#### HISTORIC AND DESIGN REVIEW COMMISSION

**HDRC CASE NO:** 2022-382

**ADDRESS:** 1024 DAWSON ST

**TYPE OF WORK:** Construction of a 2-story, rear accessory structure

EAST ELEVATION
SCALE: 3/8" = 1'-0"

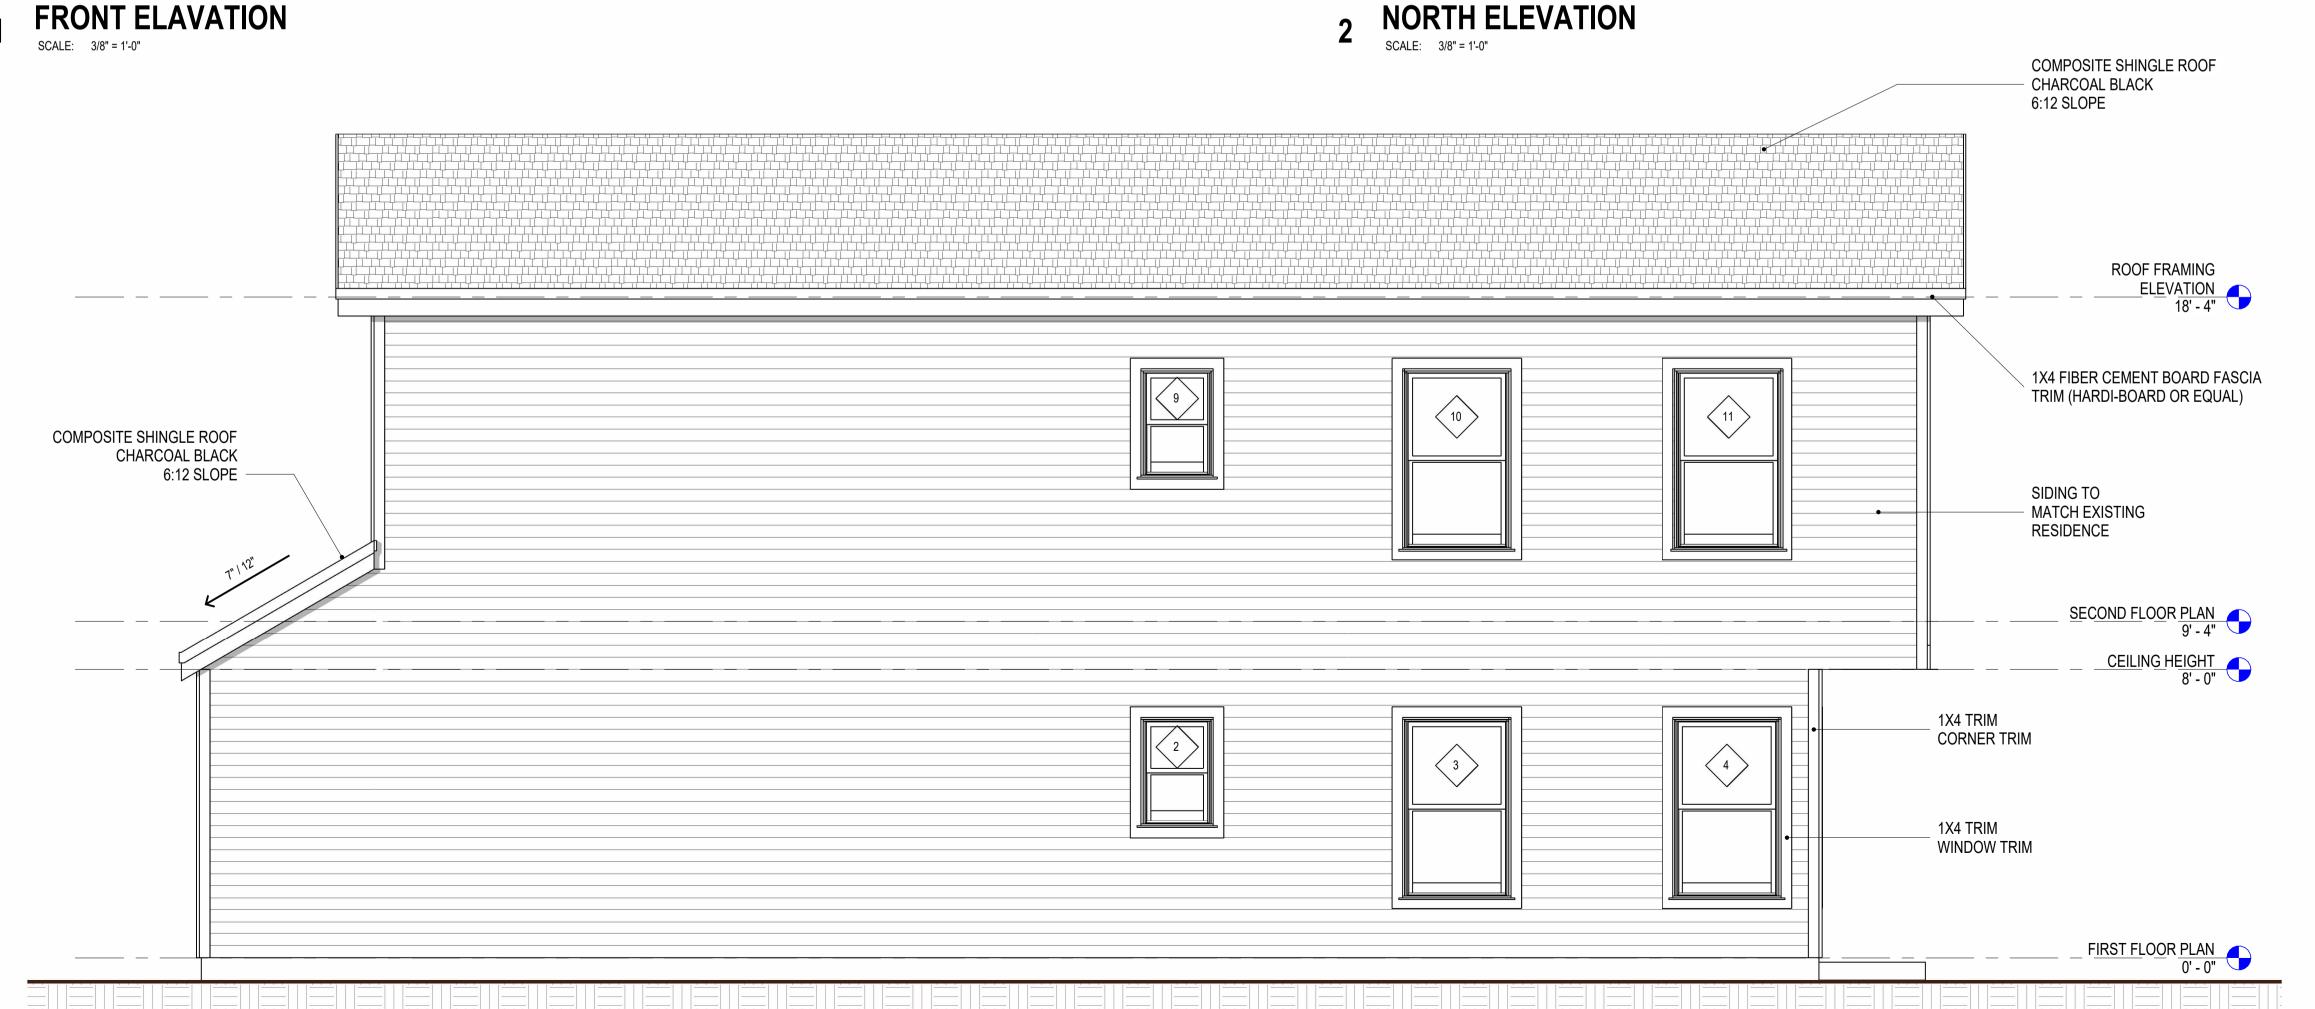
- ii. That all windows feature sash profiles, and that fenestration should be added to both the south and east elevations, which are currently either void of fenestration, or feature large, unseparated wall planes. Additionally, staff recommends that windows on the proposed accessory structure should feature profiles and sill details that are consistent with those of the primary historic structure on the lot.

- f. CHARACTER The Guidelines for New Construction 5.A. notes that new accessory structures should relate to the primary historic structure in regards to their materials and window and door openings. The applicant has noted that the proposed rear accessory structure is to feature siding and windows that will match those found historically on the primary historic structure. Generally, staff finds the proposed new construction to be appropriate; however, staff finds that the small, fixed windows on the west façade should be modified to feature traditional opening sizes in a one over one profile. Staff finds that additional fenestration should be added to both the east and west facades in locations that are currently void of fenestration. Additionally, staff finds that windows on the proposed accessory structure should feature profiles and sill details that are consistent with those of the primary historic structure on the lot.

- i. That all windows feature sash profiles, and that fenestration should be added to both the east and west elevations, which are currently either void of fenestration, or feature large, unseparated wall planes. Additionally, staff recommends that windows on the proposed accessory structure should feature profiles and sill details that are consistent with those of the primary historic structure on the lot.
- ii. That the applicant install wood or aluminum clad wood windows that are consistent with staff's standards for windows in new construction, as noted in finding h and in the applicable citations.
- iii. That the applicant revise the Dawson Alley design to feature a traditional porch element rather than a cantilevered element.

1 WEST ELEVATION
SCALE: 3/8" = 1'-0"

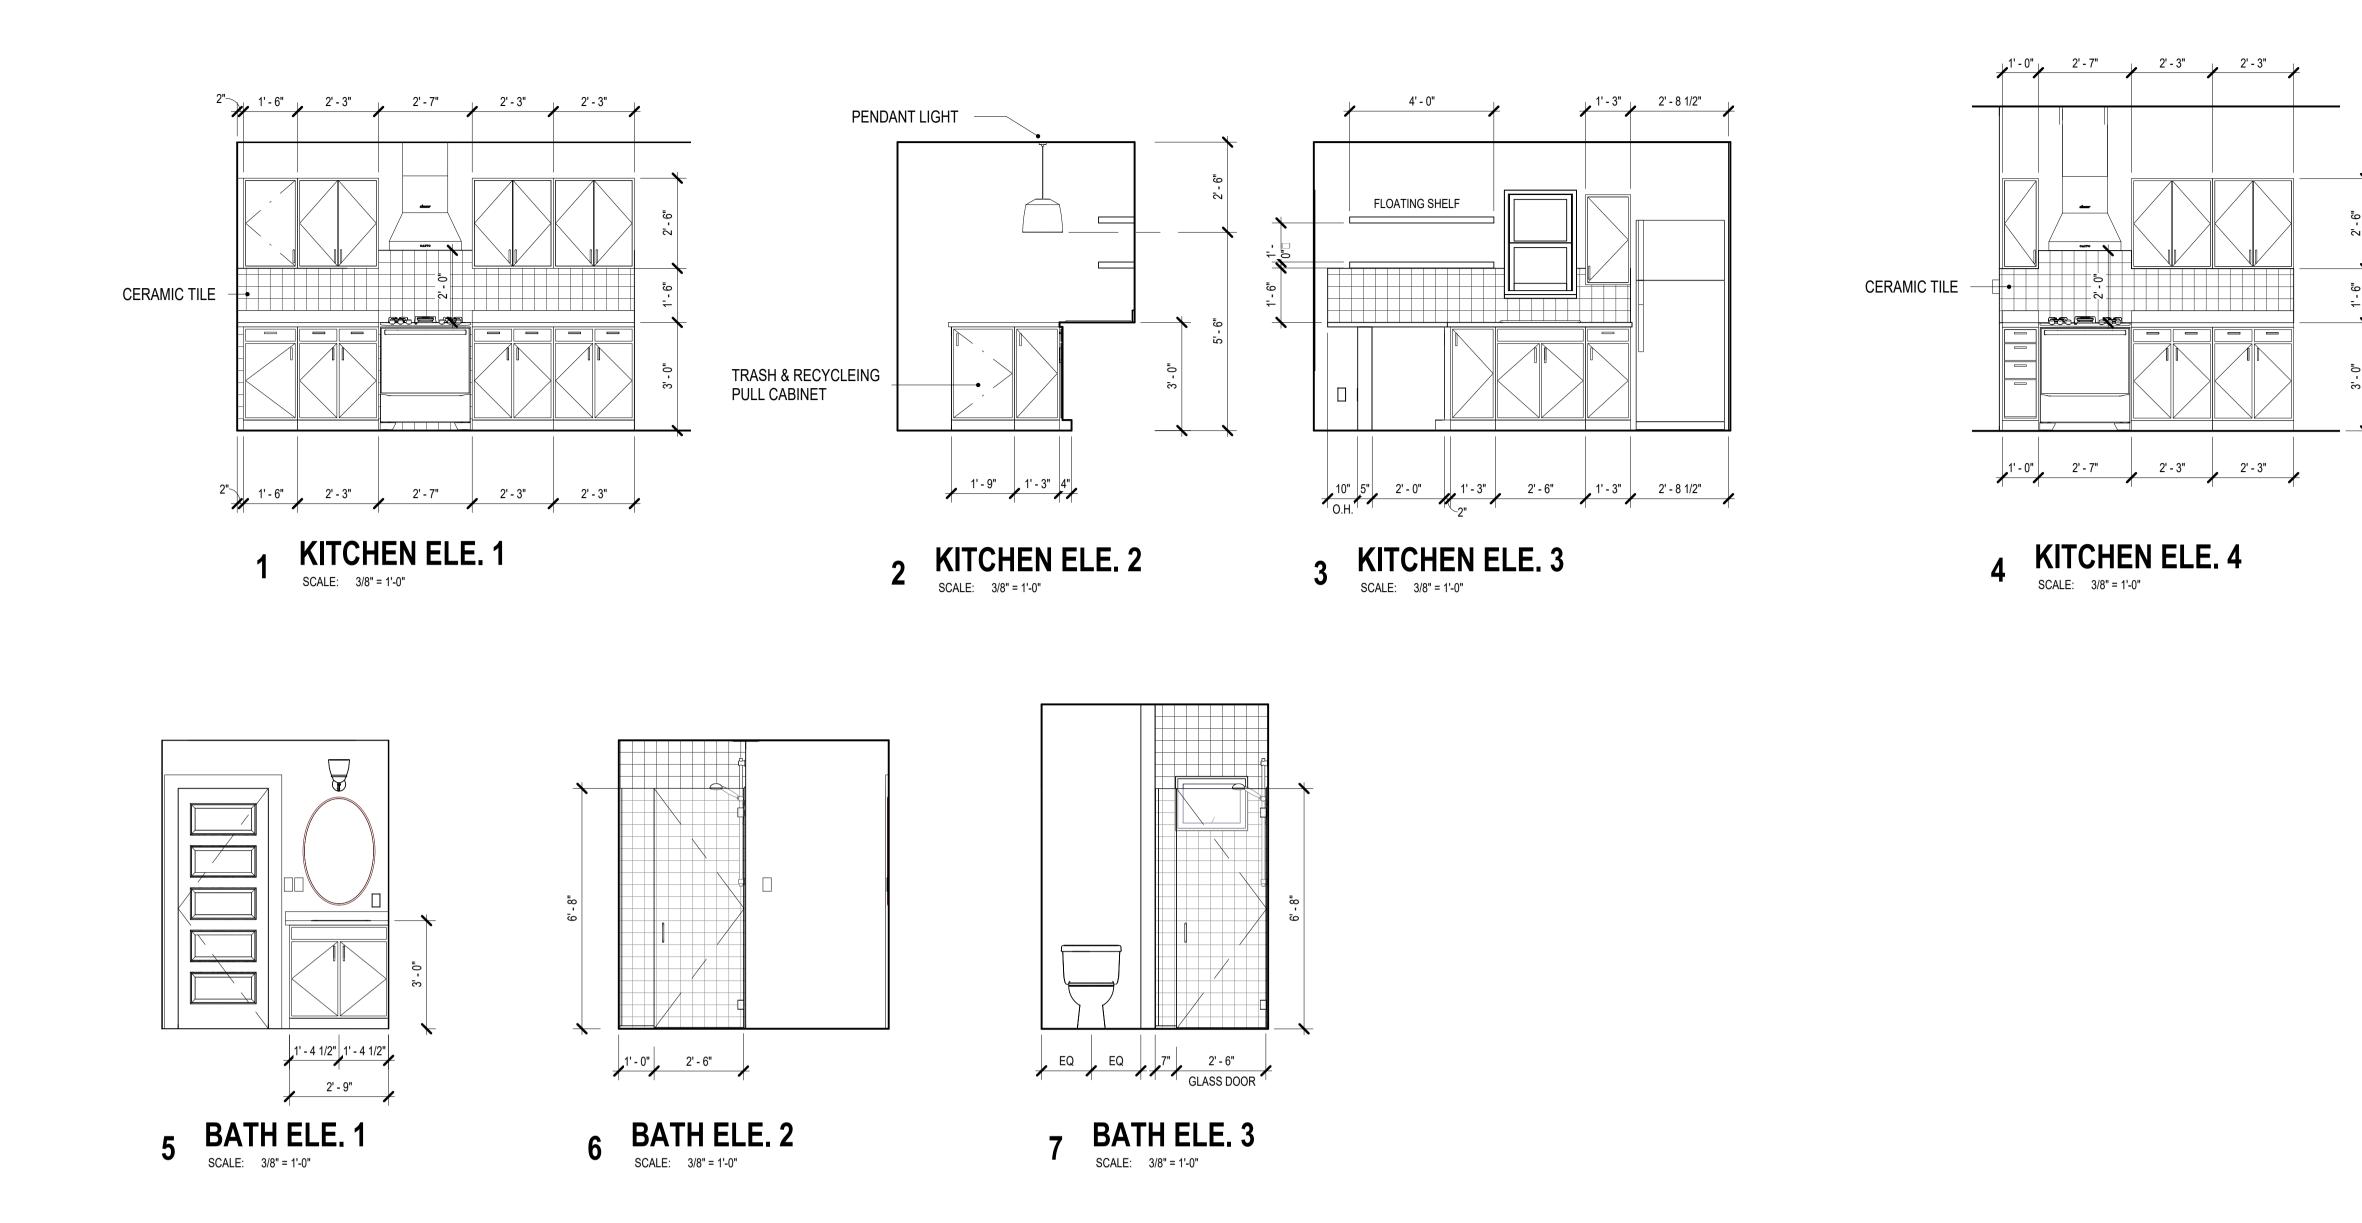
- g. CHARACTER The applicant has proposed a cantilevered profile facing the right of way at Dawson Alley. Generally, the proposed form is not found historically within the district; front porches with porch massing and detailing are, however. Staff finds that the applicant should incorporate traditional porch massing rather than cantilevered roof forms.
- h. WINDOW MATERIALS At this time the applicant has not proposed a specific window product. Staff finds that the applicant should install wood or aluminum clad wood windows that are consistent with staff's standards for windows in new construction.
